Product Change Notice

Issue Date: 20-January-2022**Change Description:**

New dice replacement for PCB base Seven Segment Display and Custom Module

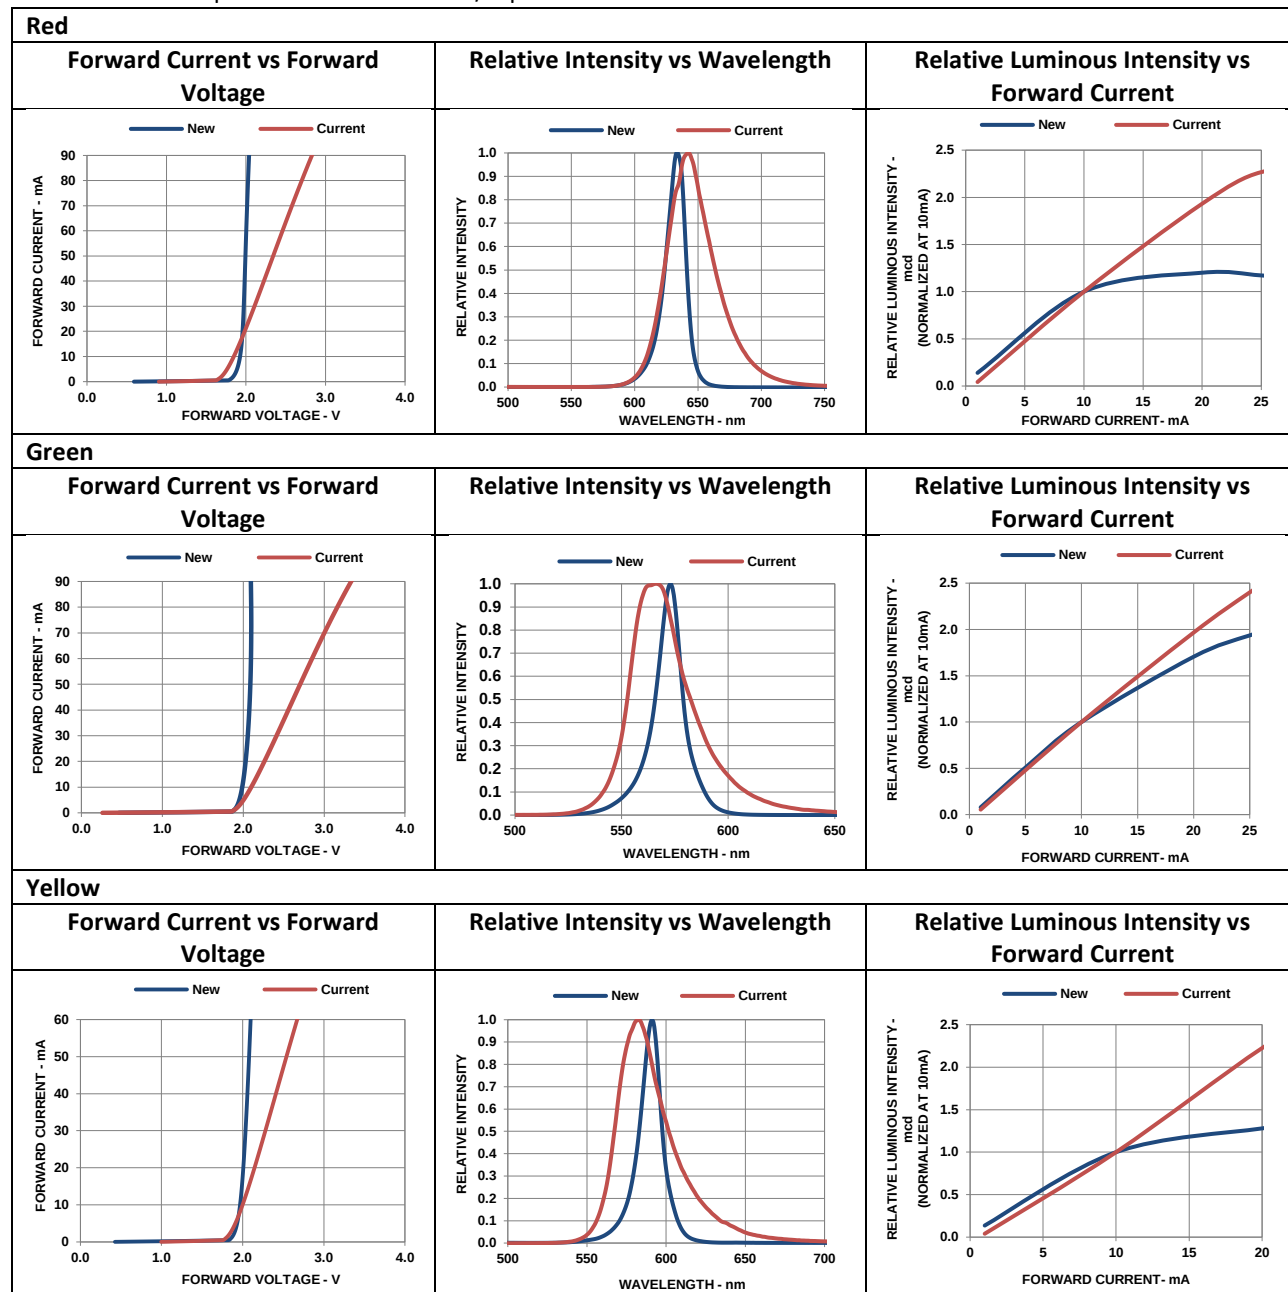
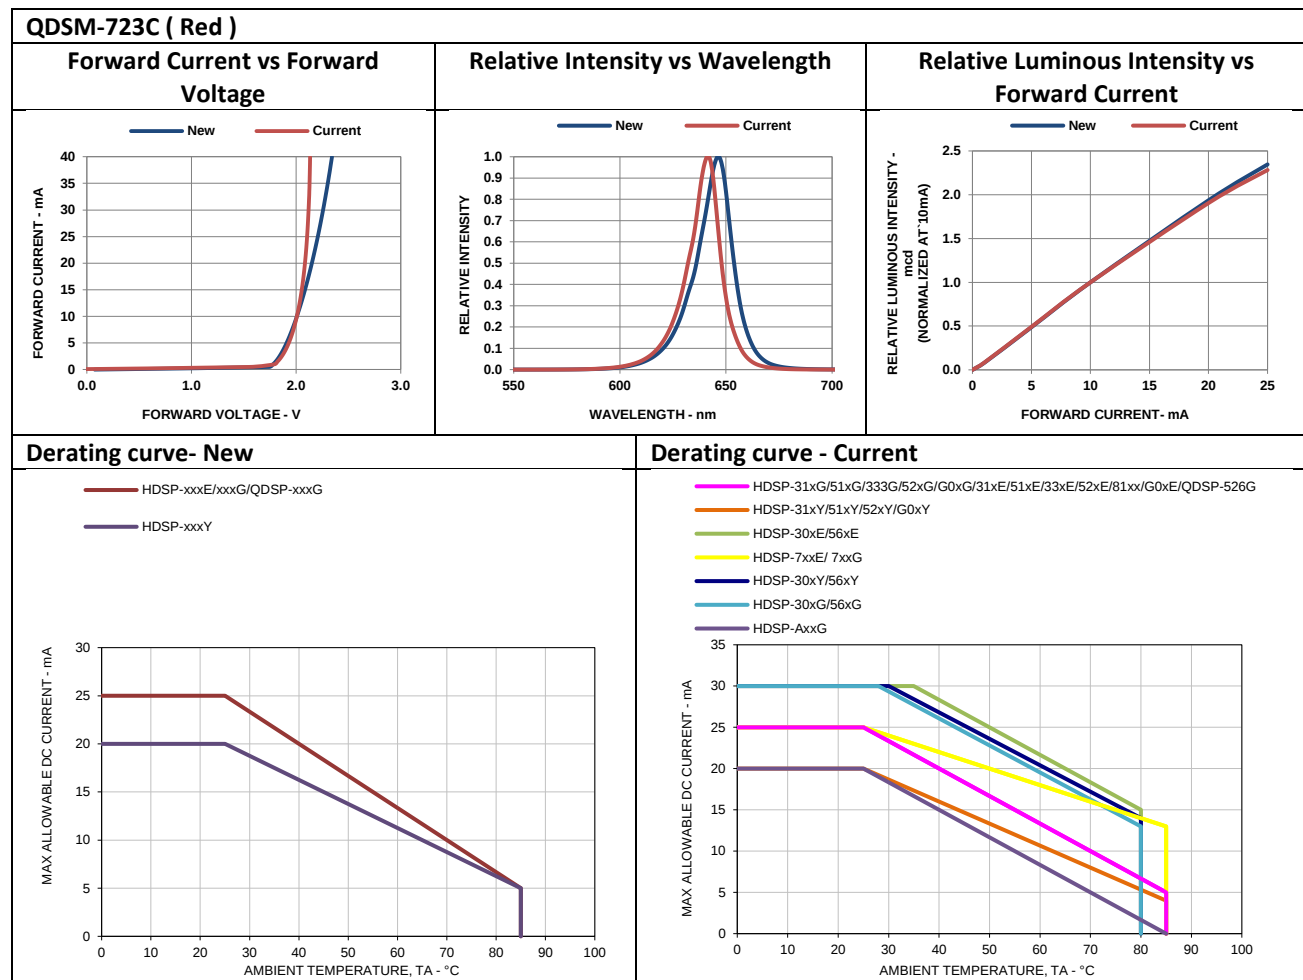
Following are changes in product characteristic:

1. Forward Voltage vs Forward Current
2. Relative Intensity vs Wavelength
3. Relative Intensity vs Forward Current
4. Storage temperature & operating temperature range will be standardized to -40°C/85°C
5. Power dissipation
6. Peak forward current
7. DC forward current
